STAFF MEMORANDUM

Subject: **Case SP #2022-03 Amherst Label Realty, LLC, Tax Map 15, Lot 15, 15 Westchester Drive**
Public Hearing for a Major Site Plan to construct a 13,305 square foot building addition, stormwater management design, and related site and landscaping improvements within the Industrial zoning district.

**Re: Amherst Label Expansion (Tax Map 15, Lot 15)
Site Plan Drainage Review**

Response Letter #1

AMHERST LABEL EXPANSION
LIGHTING PLAN

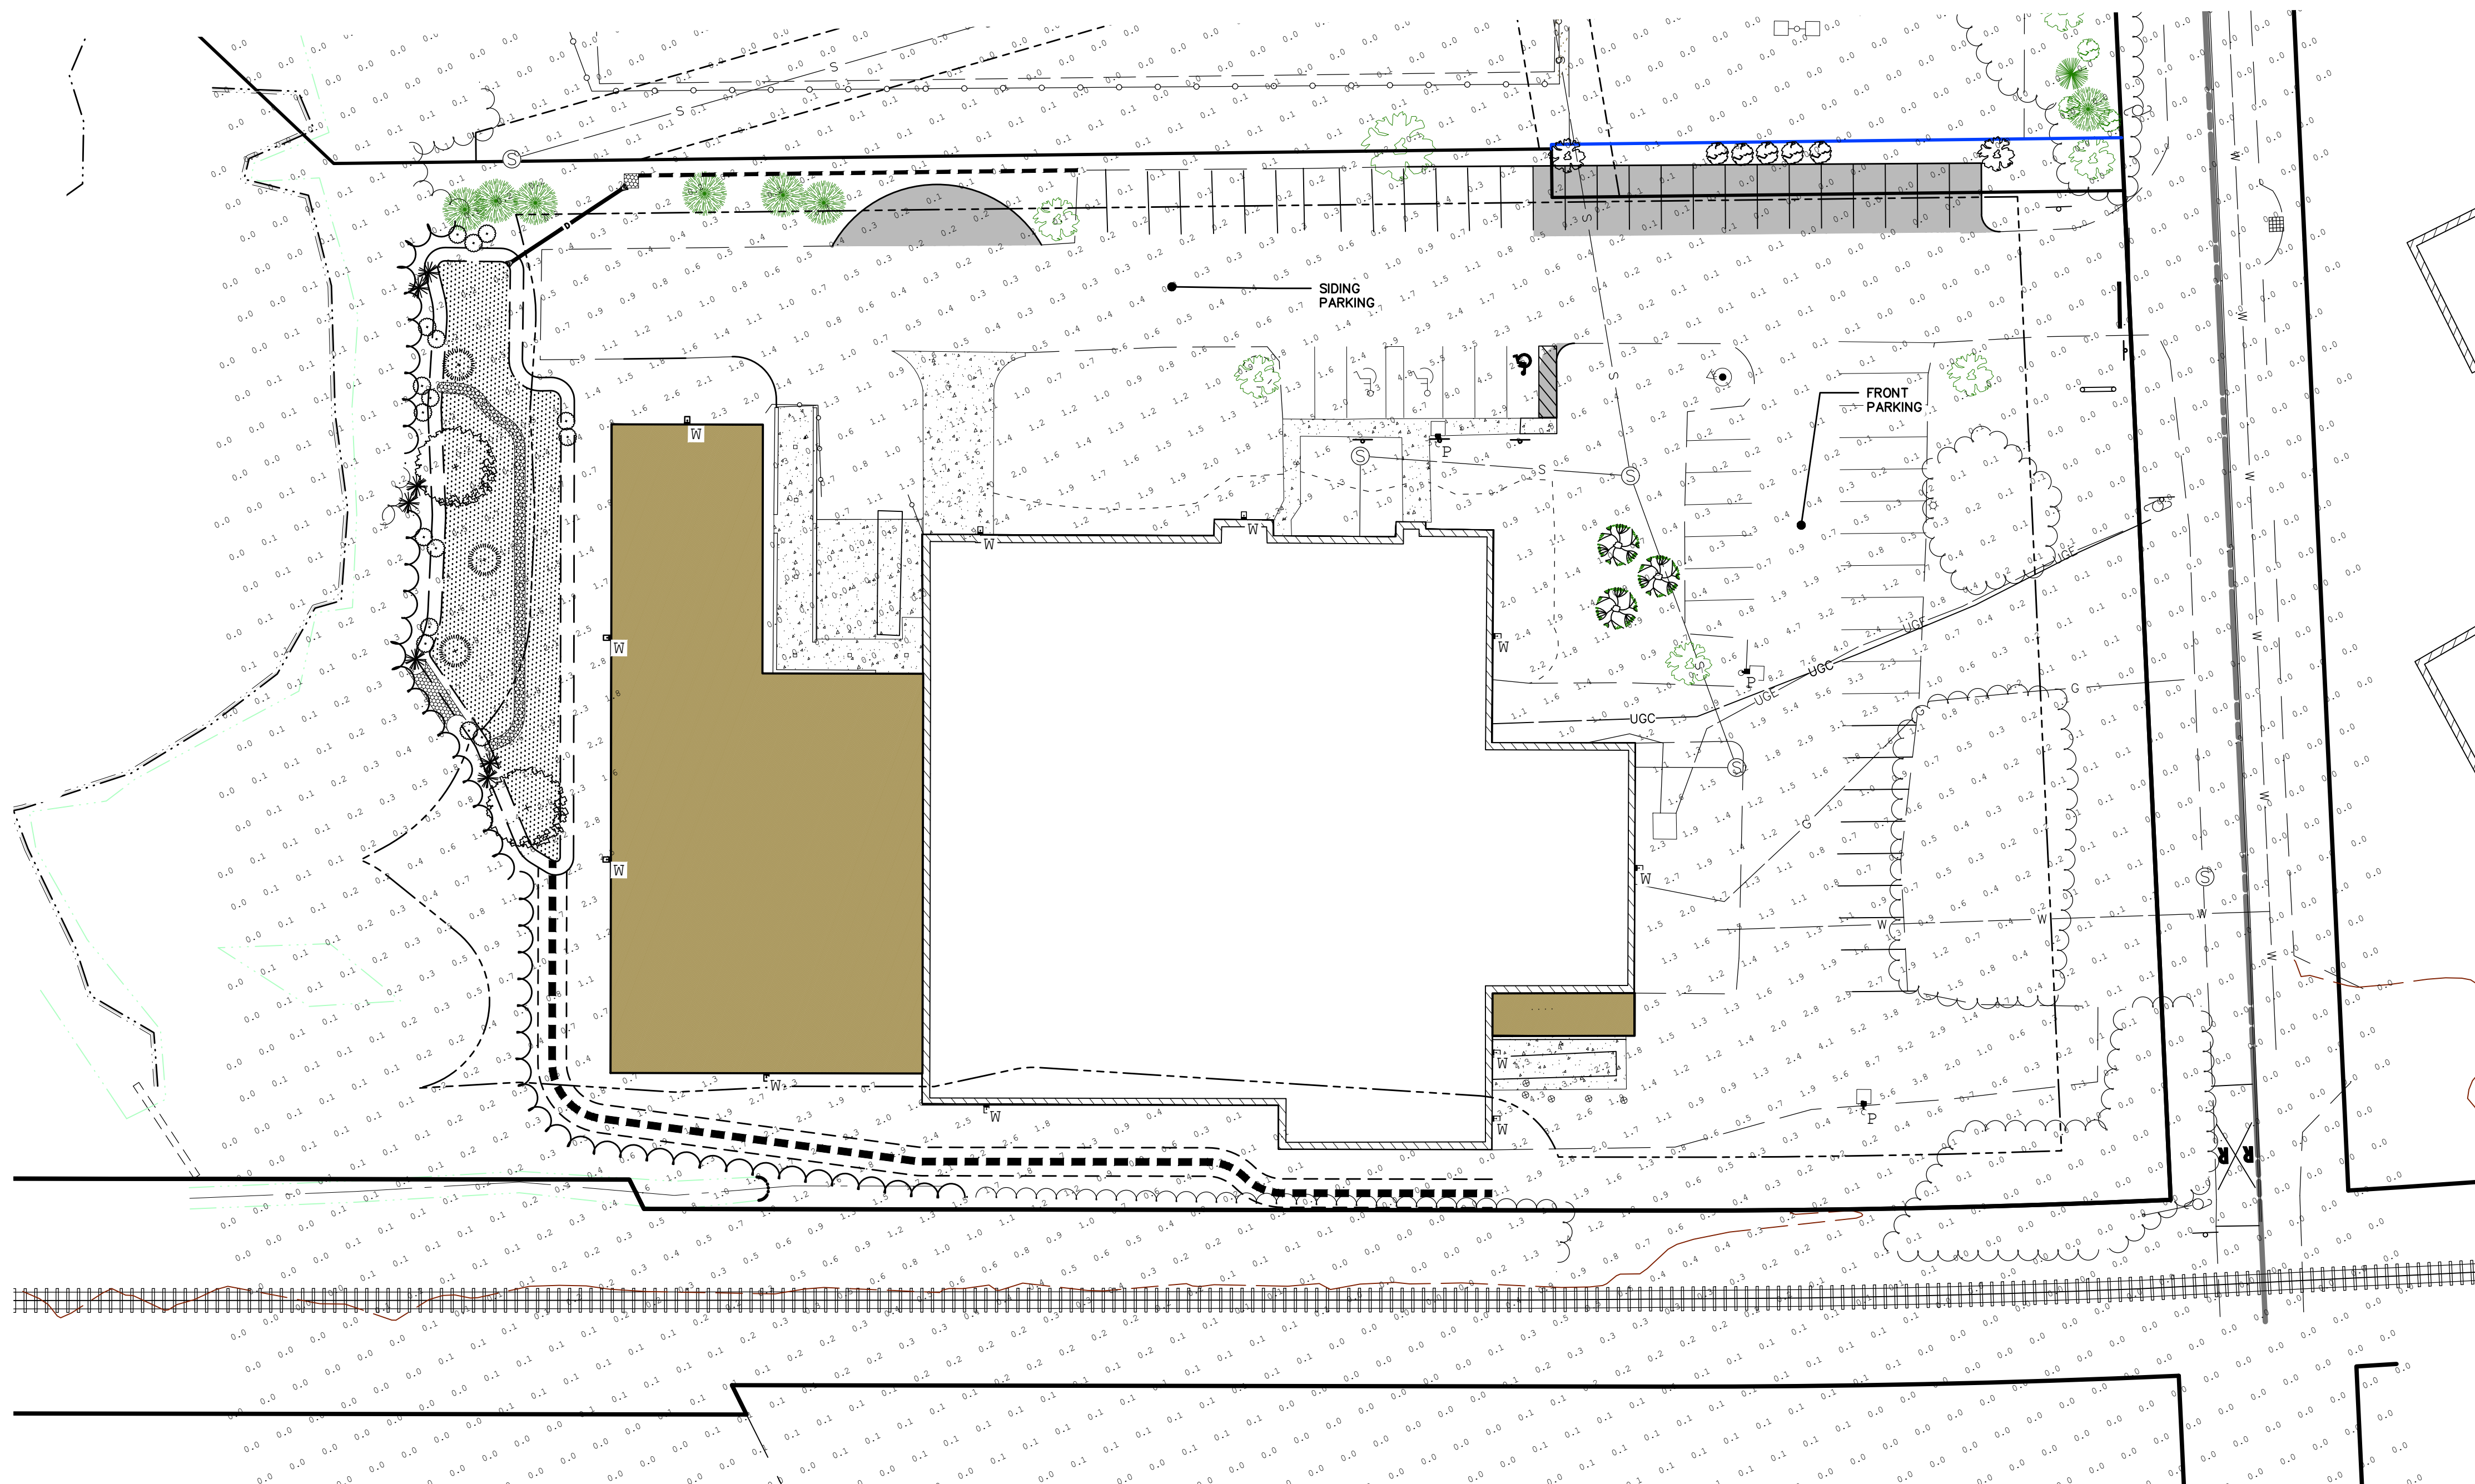
24. Question – Site Plan, Sheet 7 (LT-1). Please revise said sheet by including the cut sheets/design specifications for the wall units.

The photometric plan has been updated to include the cut sheets/design specifications for the wall units. See sheet 7.

SMOOTH INTERIOR CORRUGATED POLYETHYLENE PIPE TYPICAL DRAINAGE TRENCH (REDUCED COVER)
 (NHDOT ITEM #662.41)
 DEC. 14, 2021
 SCALE: NONE
 4 D-2

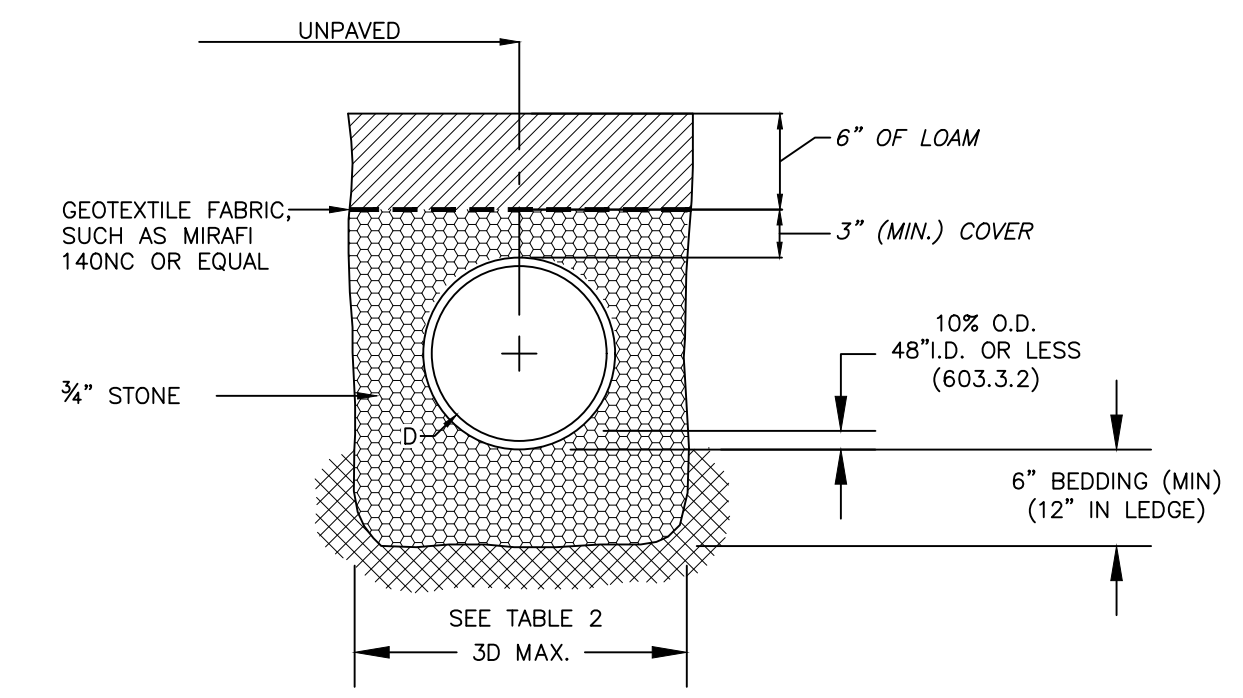
- 3. Provide details for the proposed 12" steel pipe and catch basin (inlet) in the northwest corner of the parking lot.*

The pipe has been revised to be 12" ADS pipe for availability purposes. The pipe is detailed with a reduced cover due to the limited grade changes in the area. The pipe is proposed in an area that does not require the pipe to be structural. It is proposed to have additional stone cover over the pipe to support the ground and any loading from mowing of the area. 6" of loam is proposed over the stone to allow grass to grow.

INFILTRATION BASIN - TYPICAL CROSS-SECTIONS
 SCALE: NONE
 2 D-2

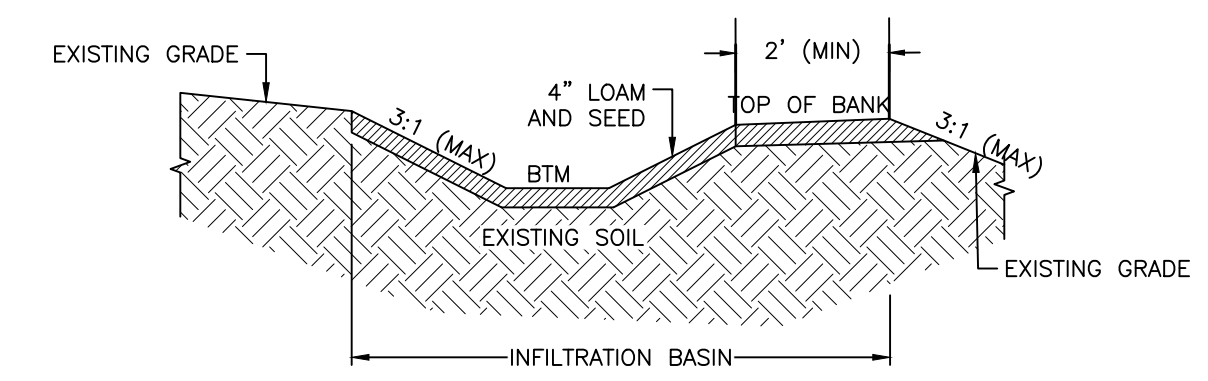
1. *Additional detail is required on the Infiltration Basin – Typical Cross Section including the width of the berm and the side slope rates (inside and outside the basin). Also, the basin detail notes “detention basin” however, the proposed pond is an infiltration basin Also, clarify how the berm between the forebay and main basin will be constructed (materials, elevations, etc.)*

A typical cross section for the infiltration basin has ben revised to change the description from “detention” to “infiltration”, include the width of the top of berm, and slope of the interior and exterior of the berm. A detail of the stone check dam forebay has been added illustrating the construction of the dam and the material to be used. See sheet 7.
